TECHNICAL BULLETIN

SU-06-05

Revision B, 4 November 2013

SUBJECT: ALTERNATE SPARE PART; SYNCHRONIZED ELEVATOR P/N 205-030-856-169 AND 205-030-856-171

FIGURE 1

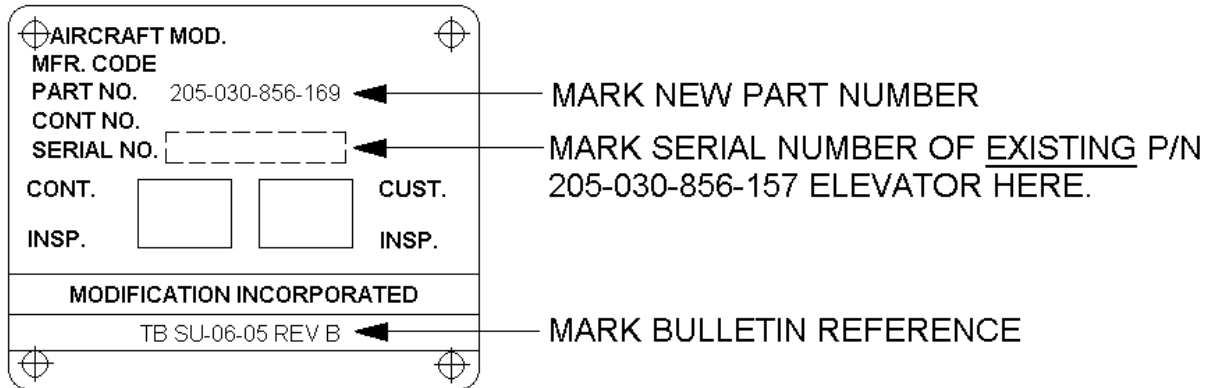
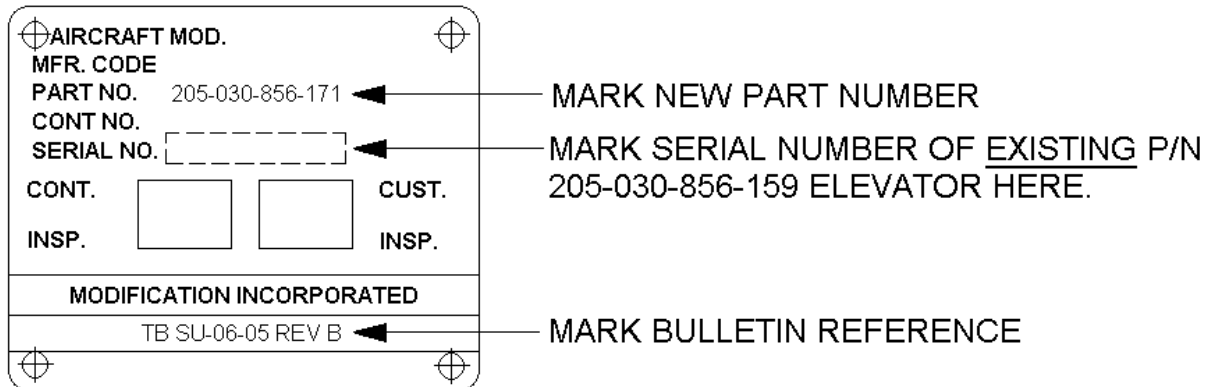
- b. Populate a P/N MS27253-1 modification plate as shown in Figure 1. Existing P/N 205-030-856-157/-159 elevator serial numbers shall not be changed or altered.

NOTE: MARK MS27253-1 MODIFICATION PLATE USING IMPRESSION STAMP, DOT PEEN, OR VIBROSCRIBE ONLY.

FOR P/N 205-030-856-157 ELEVATORS

FOR P/N 205-030-856-159 ELEVATORS

MODIFICATION PLATE FABRICATION

FIGURE 2

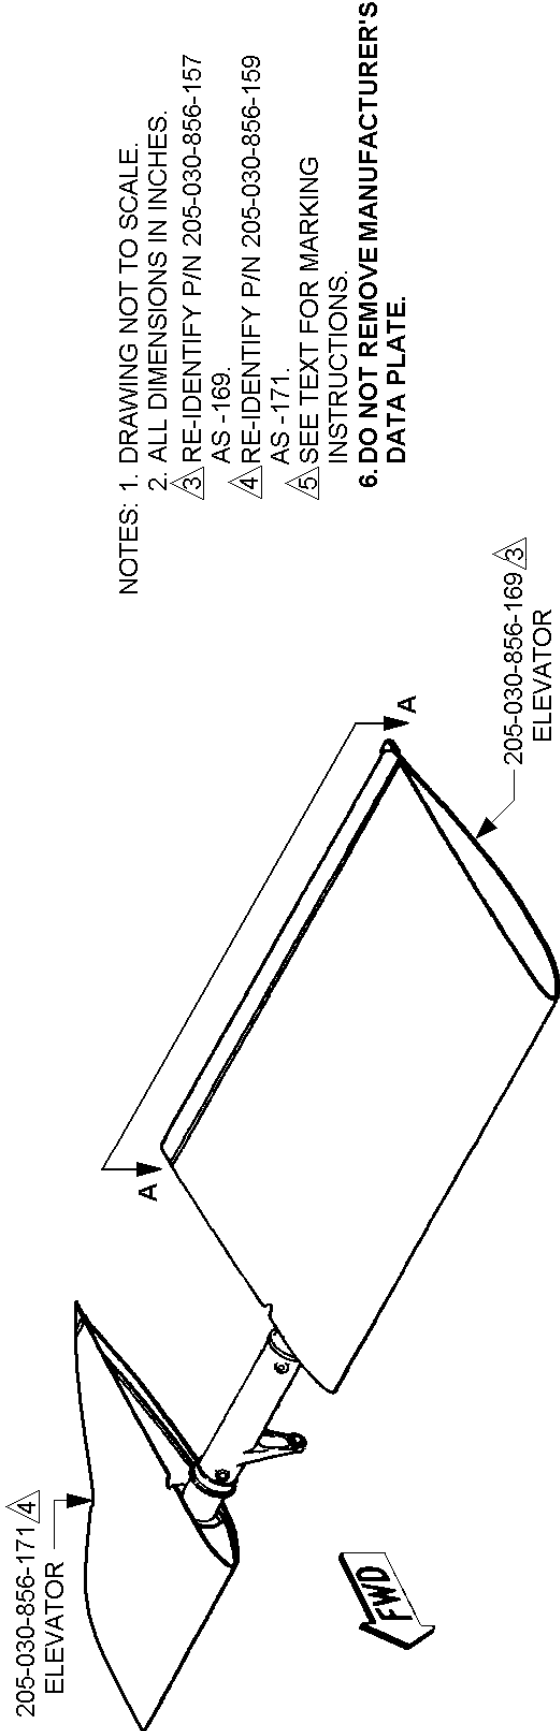
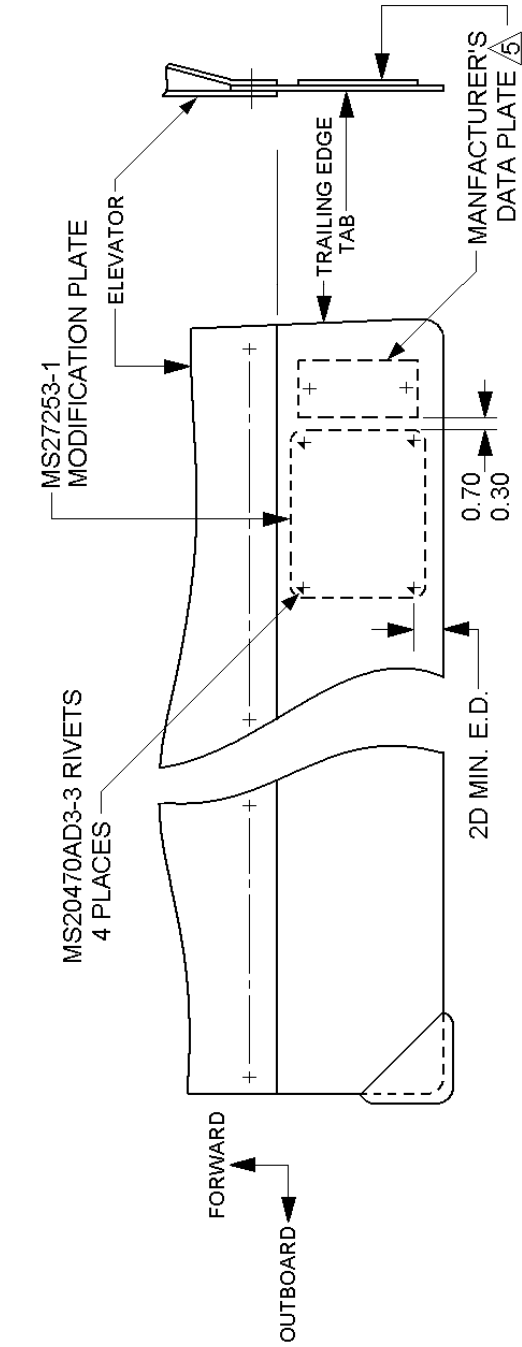
- c. Install the modification plate on the appropriate elevator assembly as shown in Figure 2. **Do not remove the existing manufacturer's data plate.**

- 1) Locate the modification plate and back drill four fastener holes in the elevator tab. Use care to not bend the tab.
 - 2) Remove the modification plate and deburr holes in the elevator tab.

- 3) Install each modification plate with four (4) MS20470AD3-3 rivets. Install fasteners with wet primer. Remove excess primer and allow primer to cure.

- NOTES: 1. DRAWING NOT TO SCALE.
 2. ALL DIMENSIONS IN INCHES.
 3. RE-IDENTIFY P/N 205-030-856-157 AS -169.
 4. RE-IDENTIFY P/N 205-030-856-159 AS -171.
 5. SEE TEXT FOR MARKING INSTRUCTIONS.
 6. DO NOT REMOVE MANUFACTURER'S DATA PLATE.

VIEW A - A
 VIEW LOOKING DOWN ON TOP OF LH ELEVATOR
 (RH ELEVATOR OPPOSITE)
